Work Order ID 92196

Item Name: Bearing

D3183-5 BEARING:
SPECIFICATION CONTROL DRAWING

DRAWING NO. D3183	TITLE BRACKET ASSEMBLY	REV.C1	DART AEROSPACE LTD ENGINEERING ORDER		D.E.O. NO. D3183-C1-1	SHEET NO. SHEET 1 OF 1	SCALE NTS
DRAWN <i>qp</i>	CHECKED <i>[Signature]</i>	MFG. APPR. <i>[Signature]</i>	APPROVED <i>[Signature]</i>		DE APPR. <i>[Signature]</i>		
DATE 10.05.14	DATE 10.06.30	DATE 10.06.30	DATE 10/06/30		DATE 10/06/30

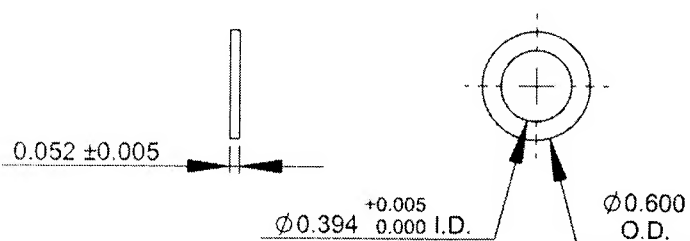
ADD POSSIBLE SUPPLIER: KML P/N 6800-ZZ

BASIC LOAD RATING REQUIREMENT: Cr = 1720 N (386 lb) MIN [DYNAMIC]
Cor = 840 N (188 lb) MIN [STATIC]
